Before the
Federal Communications Commission
Washington, D.C. 20554

In the Matter of)
)
)
Digital Audio Broadcasting Systems) MM Docket No. 99-325
And Their Impact on the Terrestrial)
Radio Broadcast Service)
)

EX PARTE COMMENTS

I, Alan W. Jurison am personally filing these *ex parte* comments and analysis in response to the *ex parte* filing of National Public Radio (“NPR”) on November 6, 2009 of an *ex parte* meeting that was held on November 5, 2009 related to the NPR Labs Advanced IBOC Coverage and Compatibility Study (“NPR Labs Study”). In addition, I have comments related to the joint letter filed by NPR and iBiquity Digital Corporation (“iBiquity”) on November 5, 2009 (“Joint Agreement”).

Figure 24 - Speech and Low Density Music at -20, -14 and -10 dBc

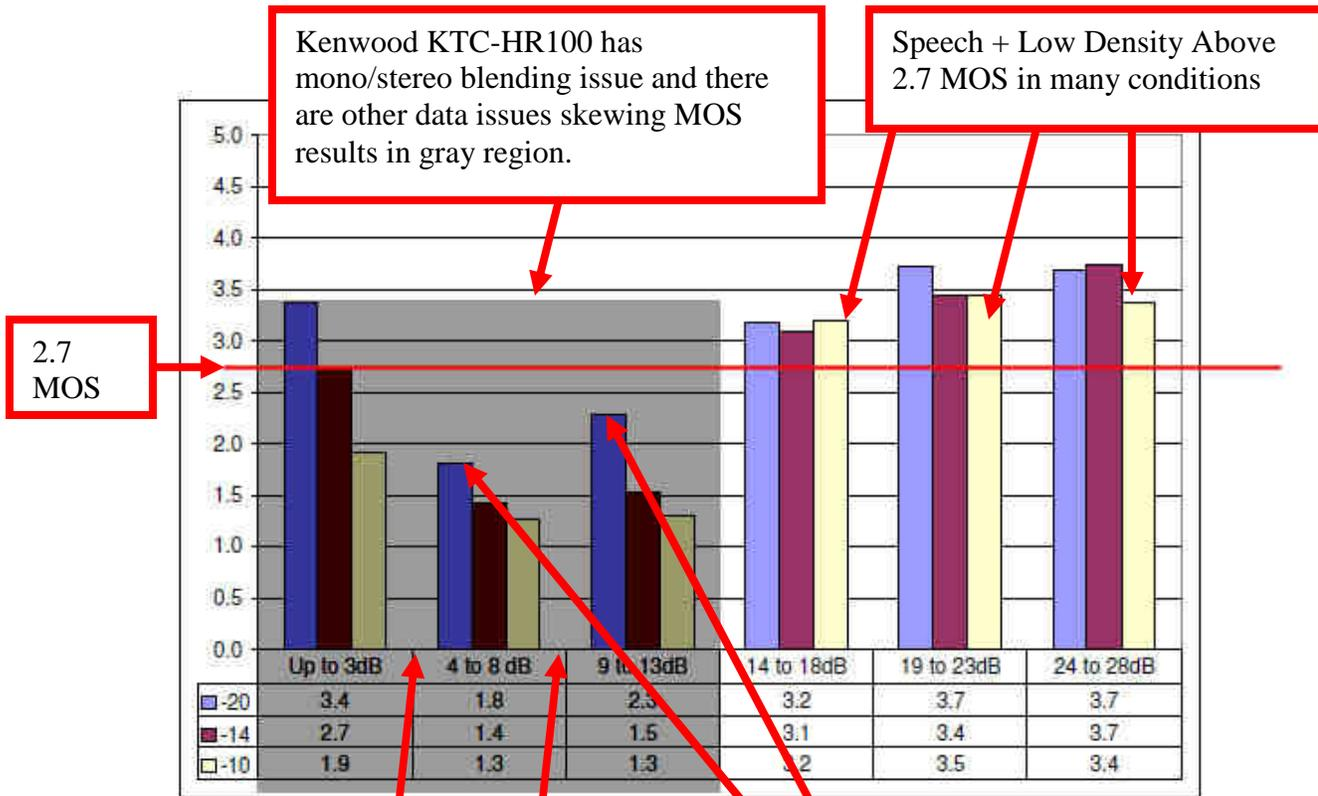
Figure 24 of the NPR Labs report shows that there is objectionable interference received in the 4 to 13dB region. However, according to their own figure, even today's digital operations of -20dBc fall below a 2.7 MOS. NPR makes no mention of this. If you are to believe the NPR report, existing IBOC operations at -20dBc already are "detrimental" because they produce scores below a 2.7 MOS, thus showing no basis for a power increase at all. Why would NPR support a power increase above -20dBc based on this data?

Clearly, there isn't much interference at the -20dBc level, otherwise there would be far more complaints filed with the Commission. Also, as I maintain above, if the analog to analog components were shown on this graph, it is likely that they would not meet the 2.7 MOS in the 4 to 13dB range either; holding IBOC digital operation to a higher interference standard than that of analog. There is an anomaly with the mono/stereo blending feature of the mobile receiver and that is making the data to look poorly. There are other issues discussed later in my report that skew these results (see Page 8 below).

Analog-Analog Components Not Shown. Trend of data here and data from Figures 21 and 22 would suggest Analog-Analog would be impaired and fall below 2.7 MOS.

-20dBc Unacceptable In These Tests. If you believe the data in Figure 24, -20dBc operation also falls below a 2.7 MOS and is allegedly already "detrimental" and causing interference.
